PUBLIC NOTICE EXETER CONSERVATION COMMISSION

1. Review of a Wetland Waiver and Shoreland CUP from Palmer & Sicard Inc., for a 26,989 SF Office/Warehouse on Holland Way (Tax Map 66-1, Planning Board Case 18-22) (*Luke Hurley, GES Inc., Christian Smith, Beals Assoc.*)

Re: Site Plan Review TRC Comments
PB Case #18-22
Tax Map Parcel #66-1

REVISED PER ENG. REVIEW	2-20-19
REVISIONS:	DATE:
LIGHTING/LANDSCAPE PLAN-L1	
PLAN FOR: COMMERCIAL DEVELOPMENT HOLLAND WAY EXETER, NH	
DATE: DEC. 2018	SCALE: 1"=40'
PROJ. NO: NH-236.52	SHEET NO. 5 OF 9

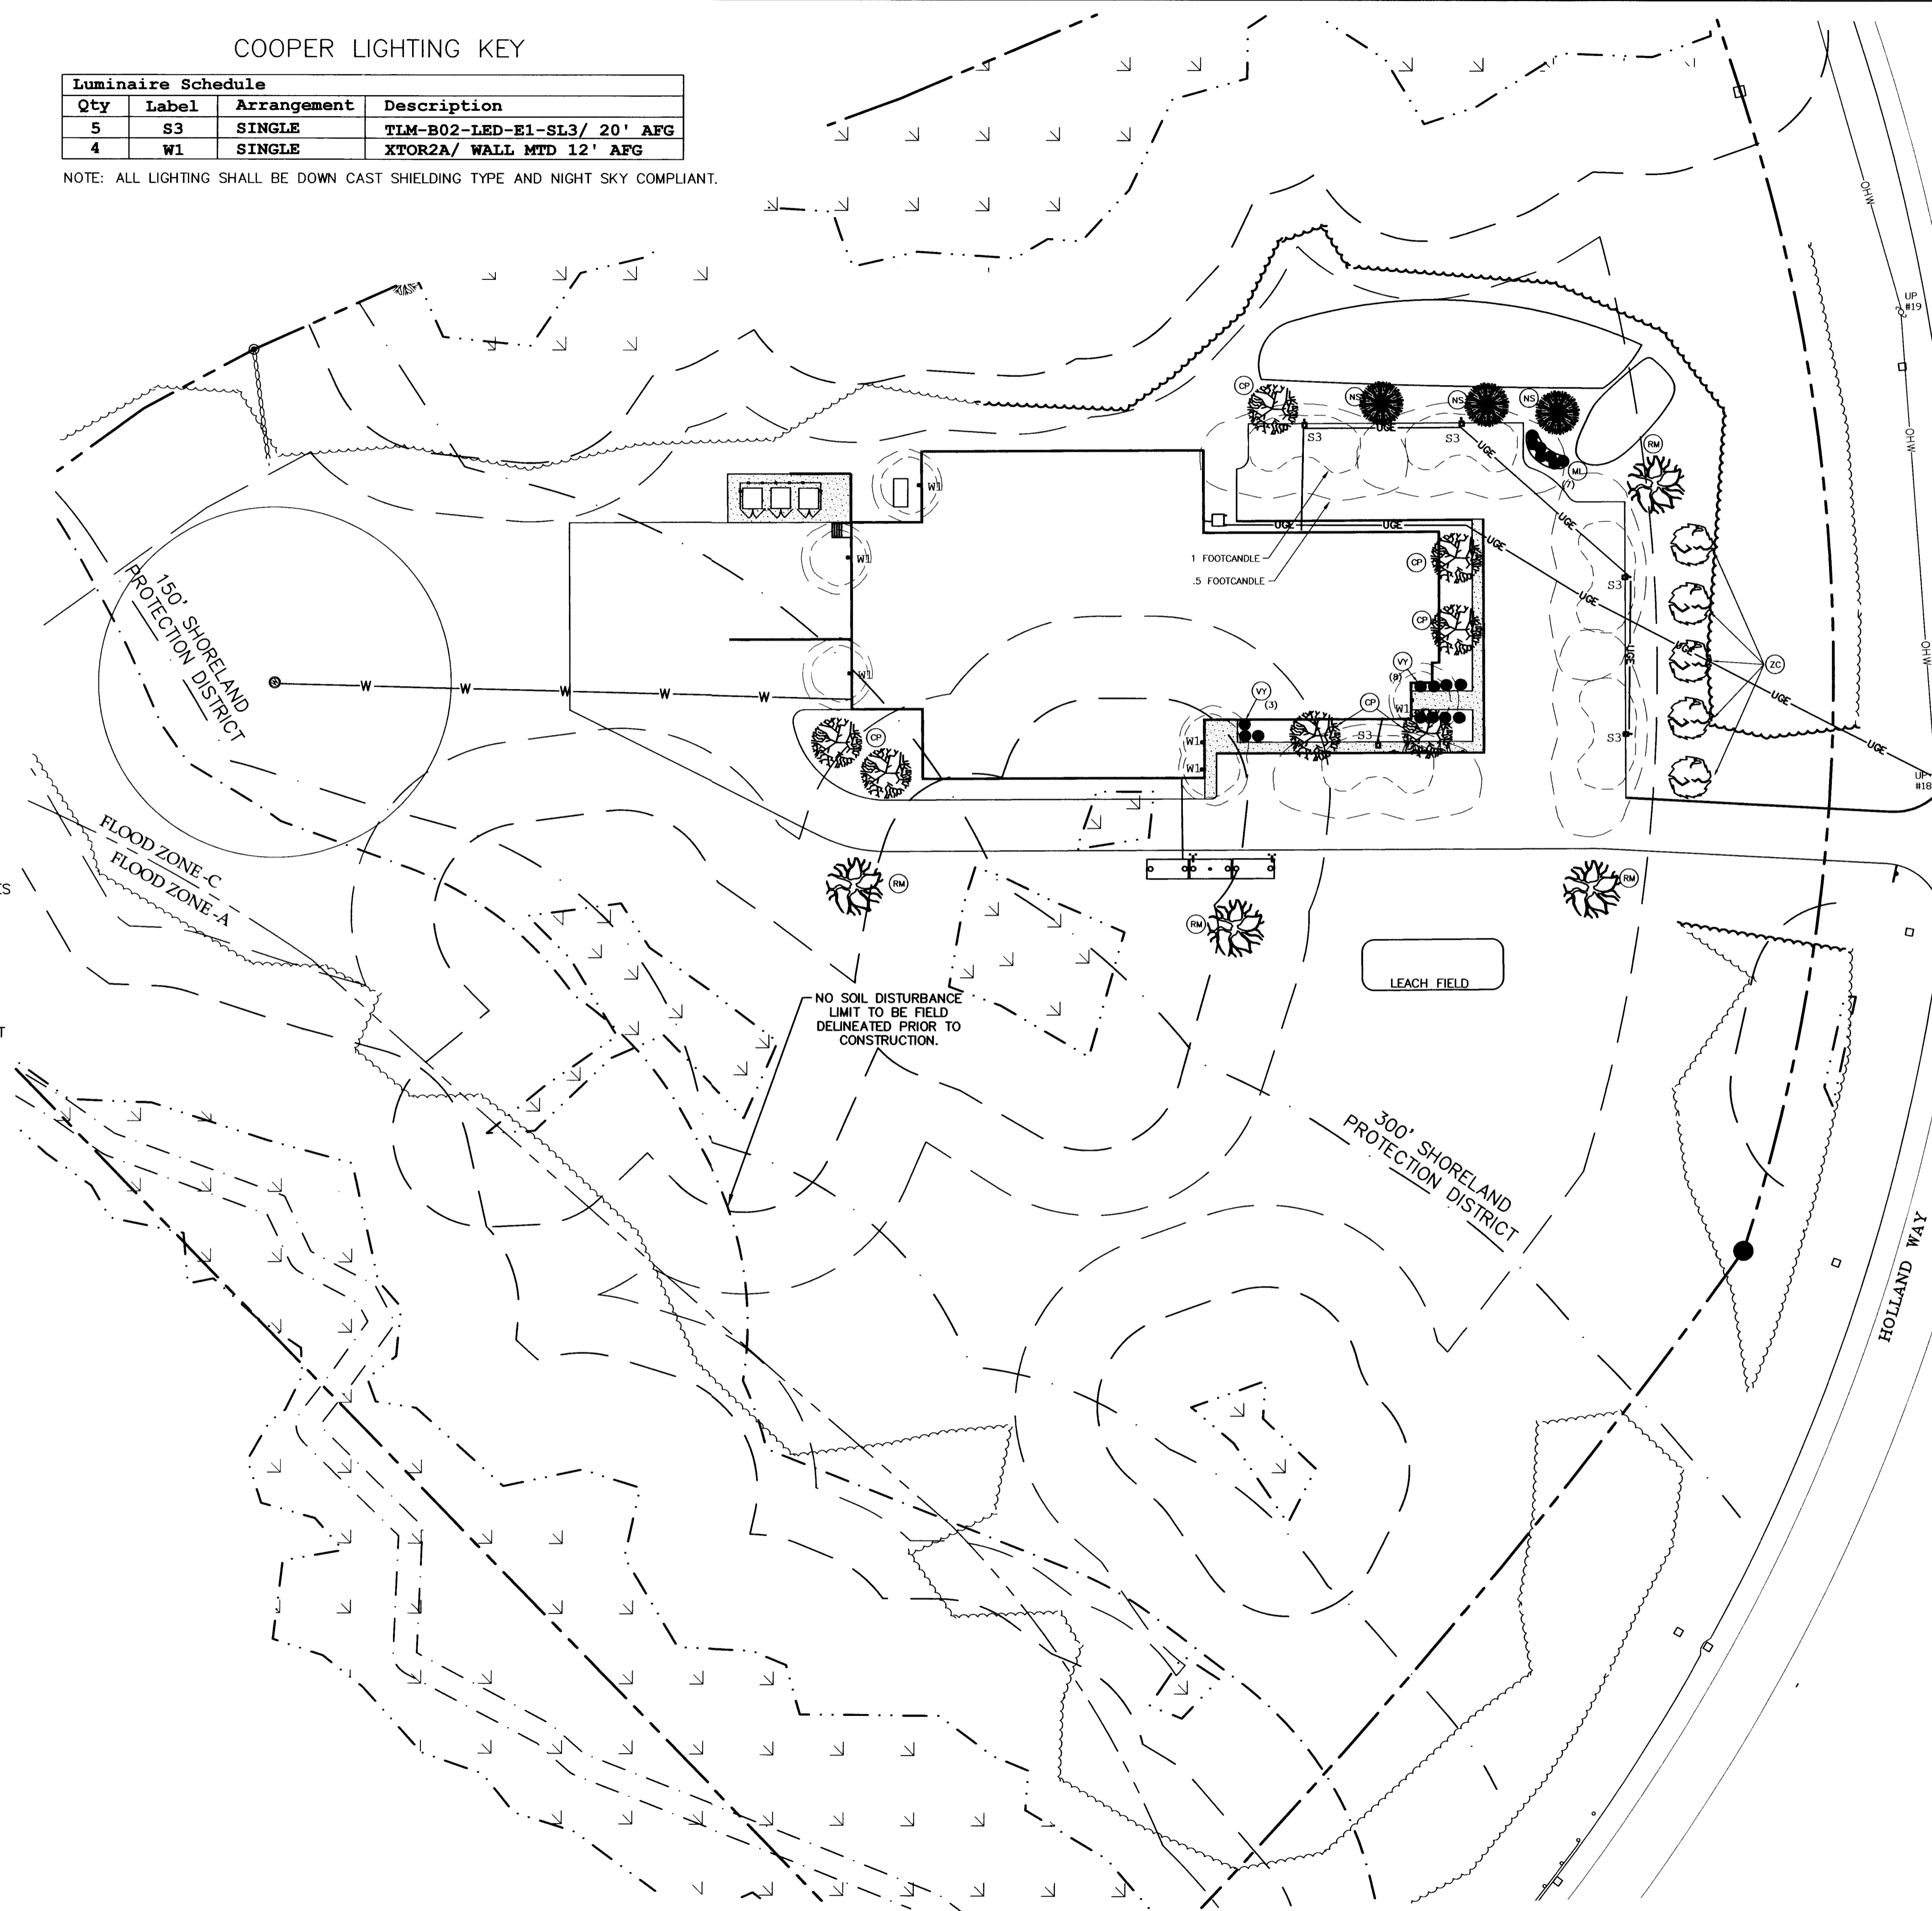
7. Sheet 5 of 9, Lighting/Landscape Plan
 - a. The foot candle contours are difficult to read. **Response: The plans have been revised for clarity.**
 - b. Coordinate the landscape plan with the utility locations to avoid conflicts. **Response: The required landscaping has been relocated to avoid conflicts.**

ENVIRO-SEPTIC DESIGN CALCULATIONS

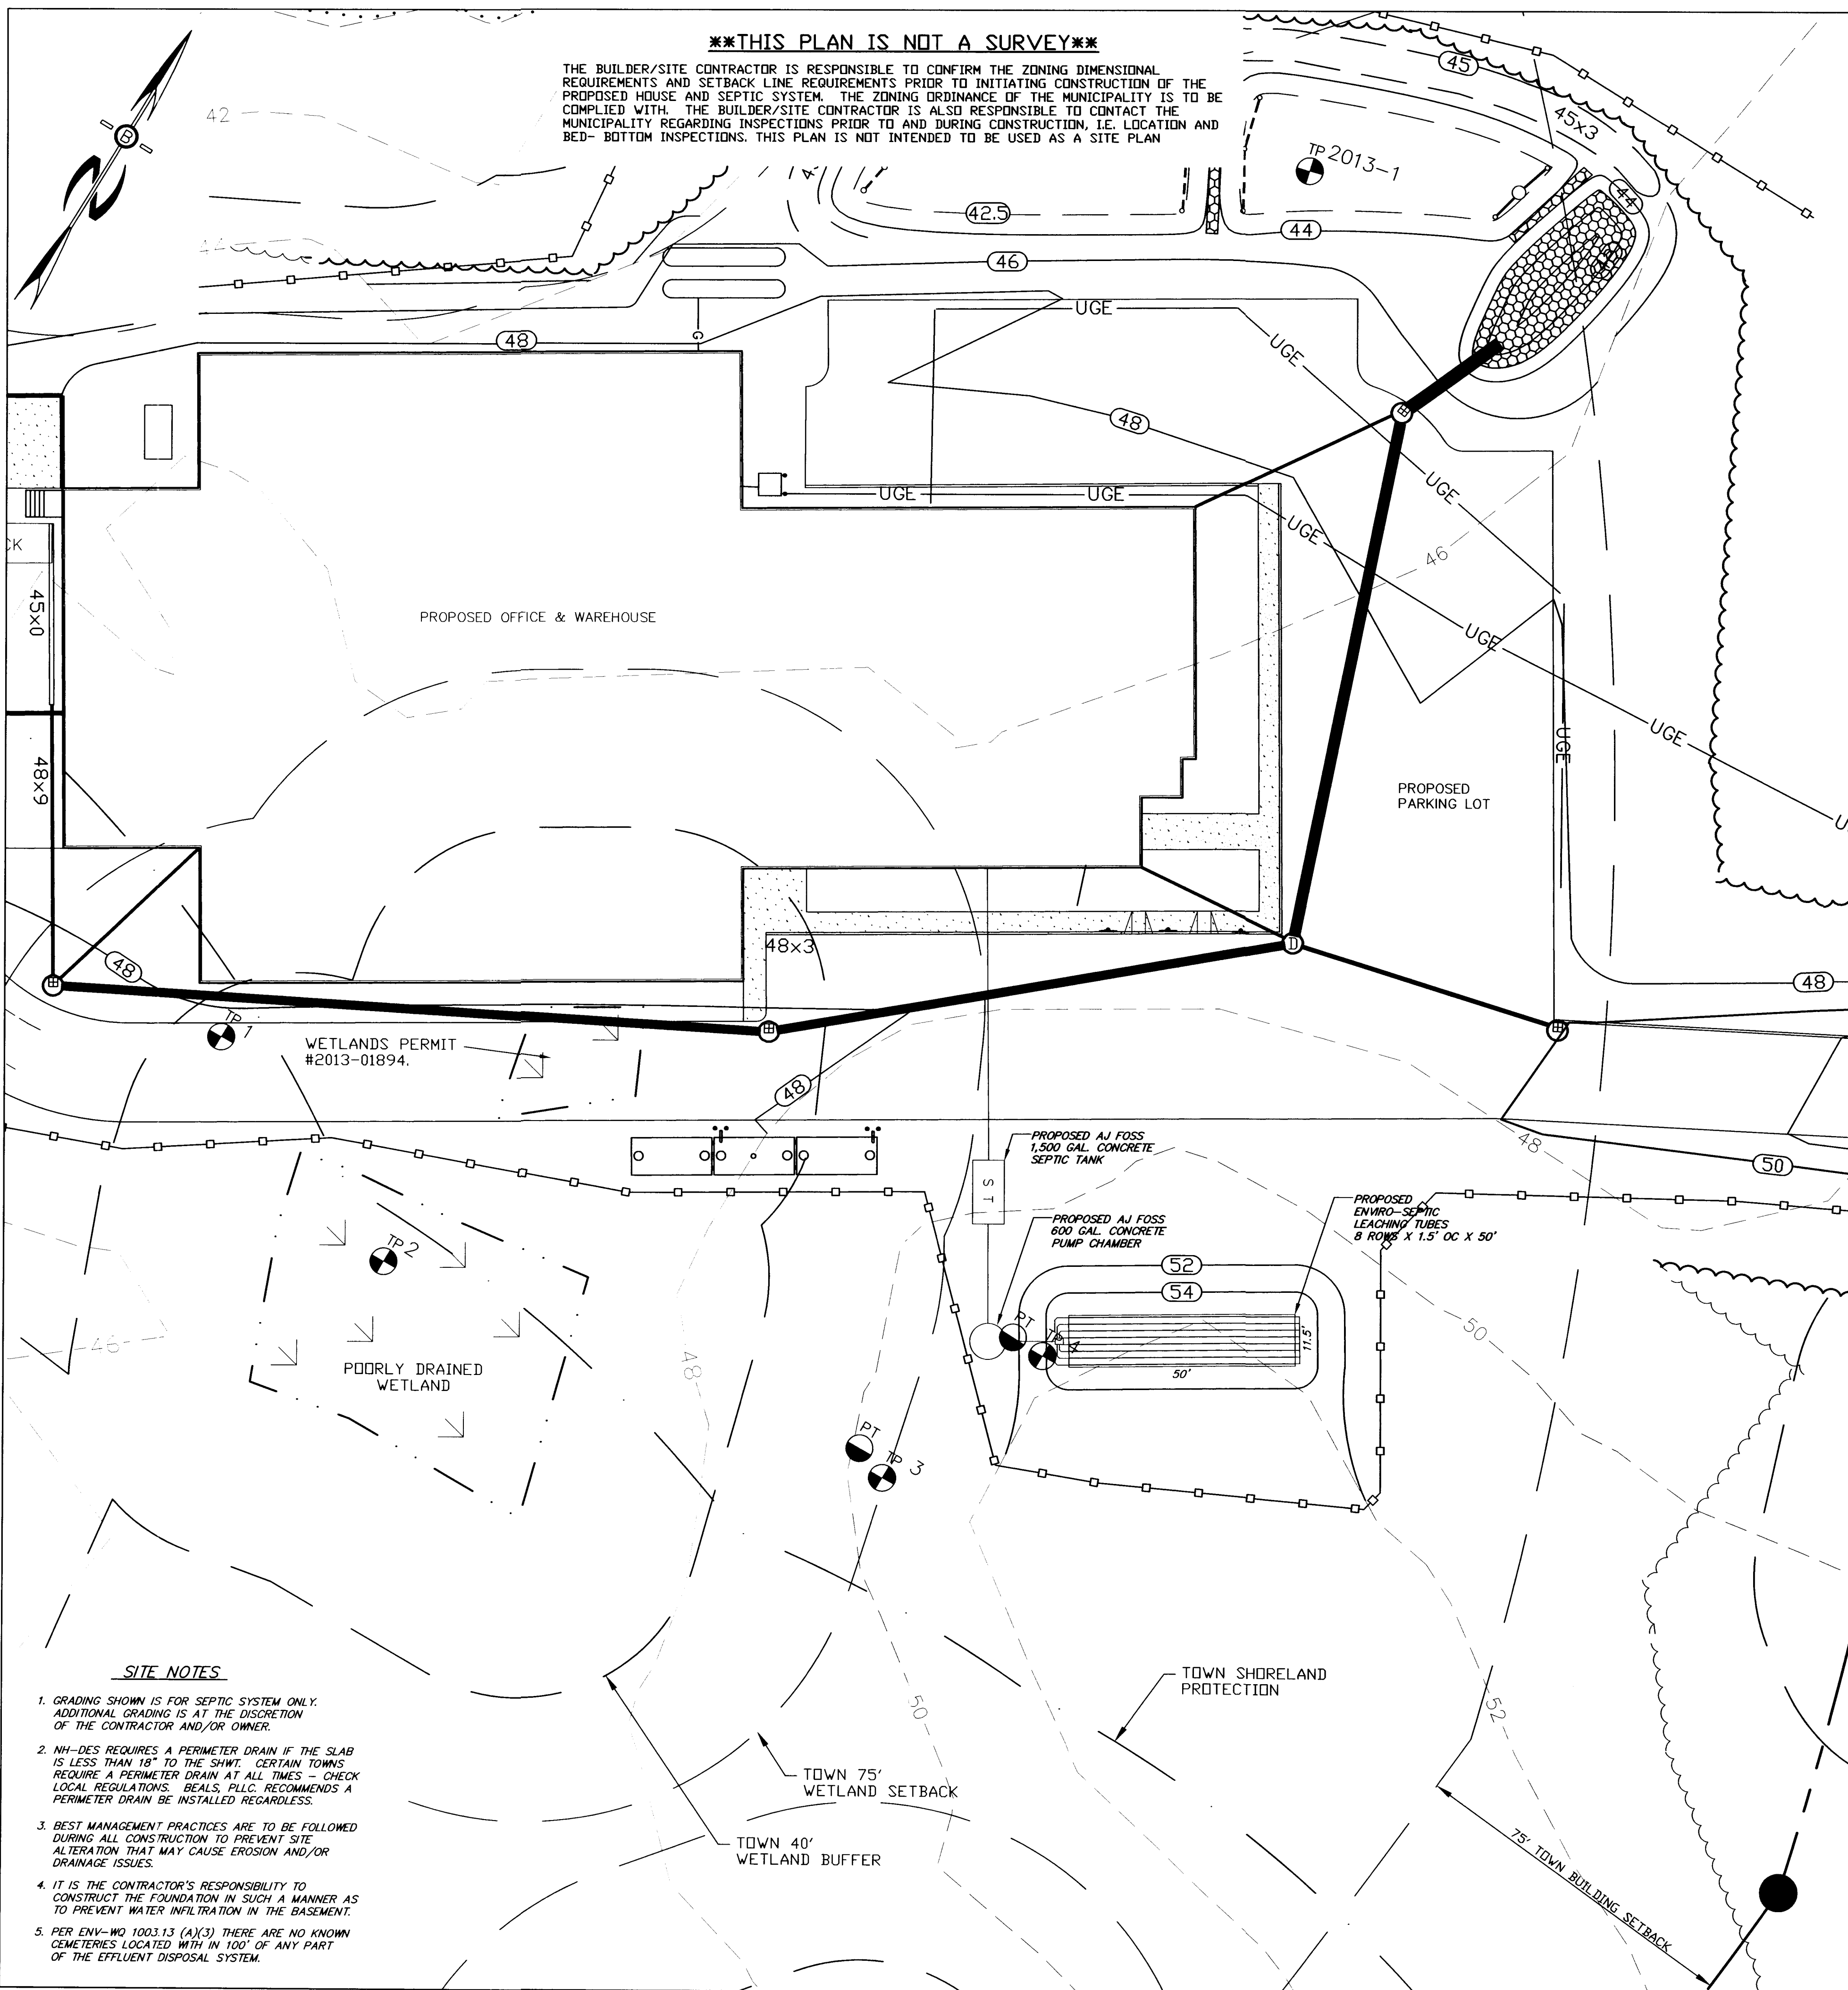
8. Sheet 6 of 9, Effluent Disposal Plan
 - a. Coordinate the employee and building size with the parking calculations. **Response: the septic plan has been revised and now coordinates with the parking calculations (office space was rounded up for the septic loading).**

31. In the Enviro-Septic Design Calculations the building area is listed as 24,869 SF. However, on Sheet 2 of 9 its listed as 29,989 SF. This should be clarified. **Response: The plans have been updated per the septic design and the outdated septic plan has been replaced with the current design.**
